Appendix C:

Disposition Tables of Responses to Comments Received from Federal Reviewers on Provincial Technical Reports

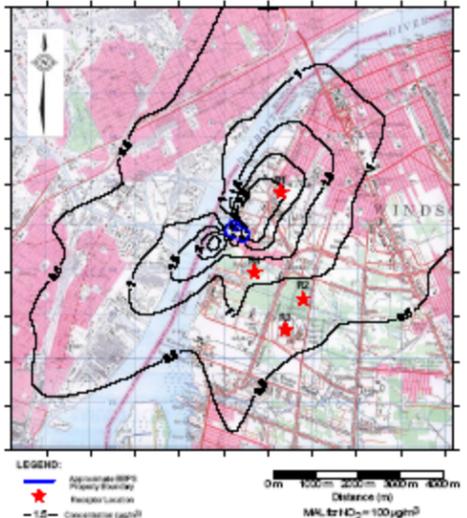
<p>Section 4.0 Overview of Model Results - In figure 4.1 the scale for PM_{2.5} concentrations does not appear to be correct.</p>	<p>The contaminant listed in Figure 4.1 is PM, not PM_{2.5}. Scale is appropriate.</p>
	<p>Section 4.4.8 PM₁₀ - Large numbers of PM₁₀ exceedance days are projected for numerous grid and sensitive receptors. Twenty of the 64 sensitive receptors in Table 4.19 were projected to have PM₁₀ exceedances on more than 50 days per year.</p> <ul style="list-style-type: none"> EC requests that the study team evaluate mitigation options to reduce the projected PM₁₀ exceedances. We note that some reduction in exceedances will result from the modifications outlined in the Recommended Plan Analysis. 	<p>Elevated exceedances are due to the assumption of the 90th percentile background concentrations occurring for 365 days of the year. See Air Quality Impact Assessment Supplementary Documentation Section 4 for a detailed discussion on elevated exceedances. When a more representative background choice is used, exceedances are primarily driven by background conditions. Mitigation options will consider EC recommendations MTO has approved</p>
